**State Significant Development SSD 8993 – SCEGGS Darlinghurst concept approval of the 2040 Masterplan and Stage 1 works**

## **ATTACHMENT A**

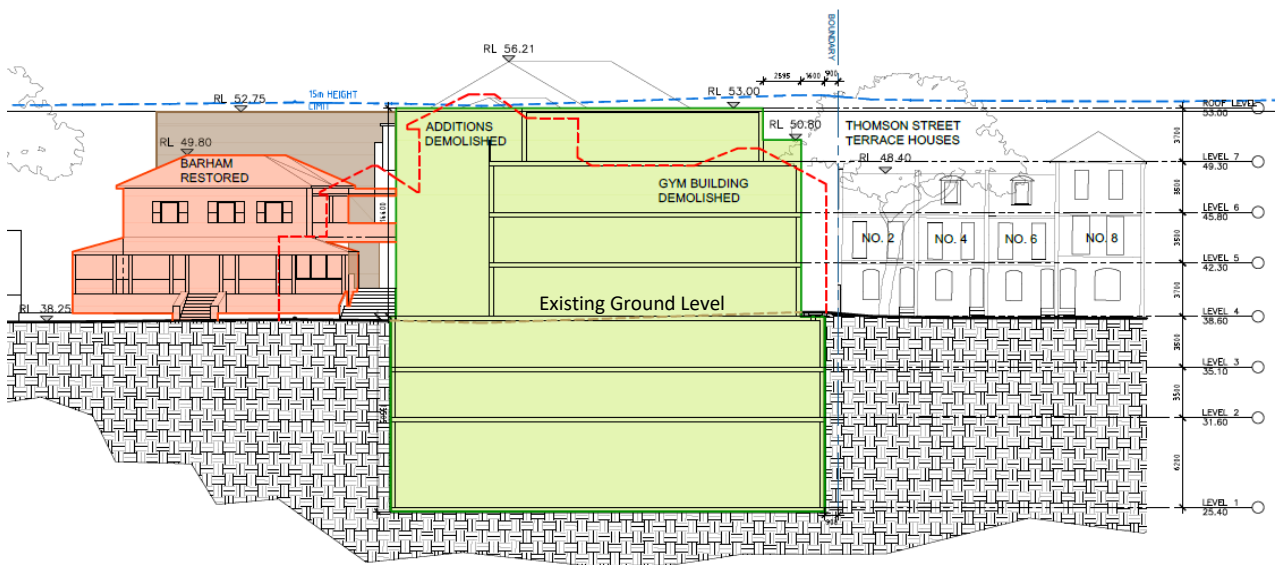
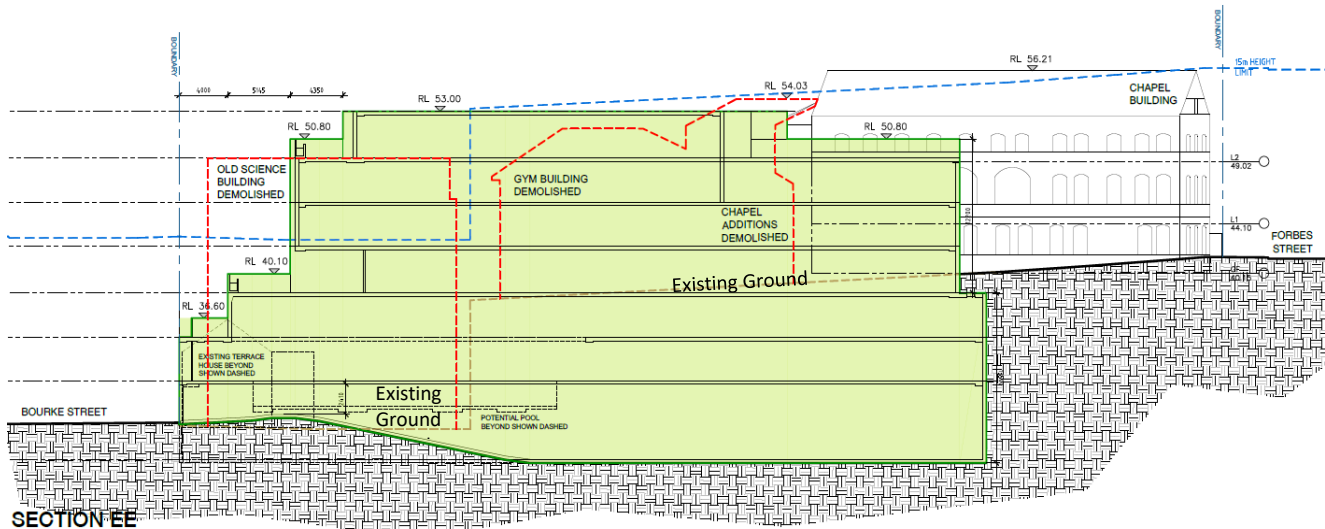
The bulk of the proposed building envelope located between Forbes Street and the existing Barham building is significantly larger than the existing structure. The proposed envelope has the potential to obscure Barham building from Forbes Street.

The new building envelope is to the street alignment and has the potential to dominate the Chapel building.

The proposed envelope cannot be supported in its current form and needs further refinement to be sympathetic, particularly to the most important building on the site – the Barham building.

SECTION GG

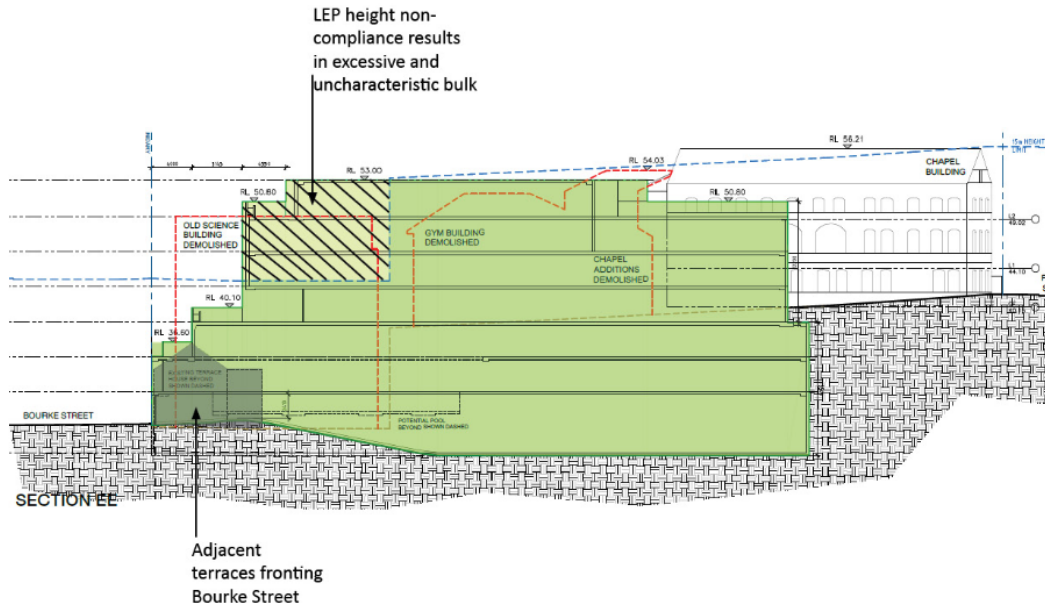
In considering whether development exhibits design excellence, the consent authority must have regard to heritage and streetscape constraints and the bulk, massing and modulation of buildings under subclauses 6.21 (4)(d)(iii) and (v) of the LEP. The proposed building envelopes provides a generally appropriate scale to Bourke Street at the boundary, but rises very quickly (in breach of the maximum height) taking cues from the detracting building it is replacing rather than the controls or what is appropriate in the context. Section EE from the submitted drawings shows clearly the breach of height. The result is an envelope that is over-scaled, excessively bulky and too high, resulting in a poor streetscape outcome.

The proposed envelope for the new multi-purpose building would provide a better fit with the context of Bourke Street and the conservation area if it complied with the maximum height control in the LEP. The diagram below shows a preferable outcome that would provide a balance between additional GFA for the school and an improved fit within the streetscape.

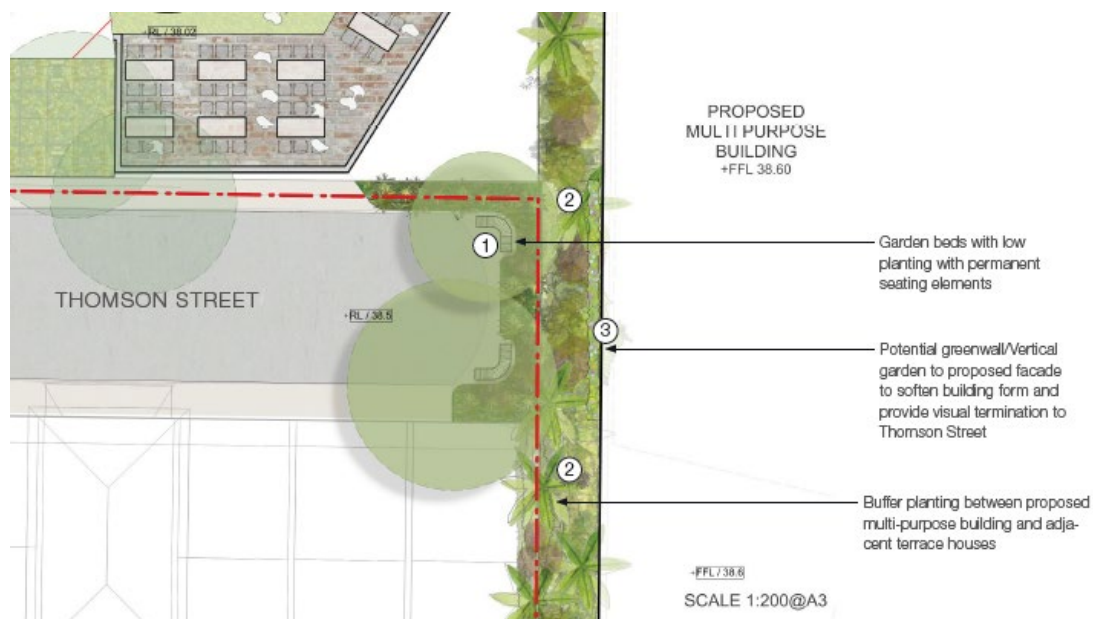
The submitted masterplan and demolition drawings include the provision of a new Bourke Street driveway, removal of street trees on Bourke Street and Thomson Street, alterations to the existing kerbside parking arrangements on Bourke Street, and removal of trees within the site itself. The landscape drawings also include new public infrastructure in Thomson Street (refer Note 1 in extract below).

It is recommended that in the event of a favourable determination of this SSD, the Department make it clear that no approval is granted for all of these elements, particularly noting the following:

- All these works are associated with the future Stage 2 and 3 of the masterplan (proposed to commence the earliest in 2025 and 2030 respectively). These future Stages will be the subject of separate detailed DAs. It is premature to grant consent to these elements as part of a concept proposal.
- Most of the identified works are on public land outside of the development site. Separate consent is required from the City (including the Local Pedestrian, Cycling and Traffic Calming Committee) for these elements.
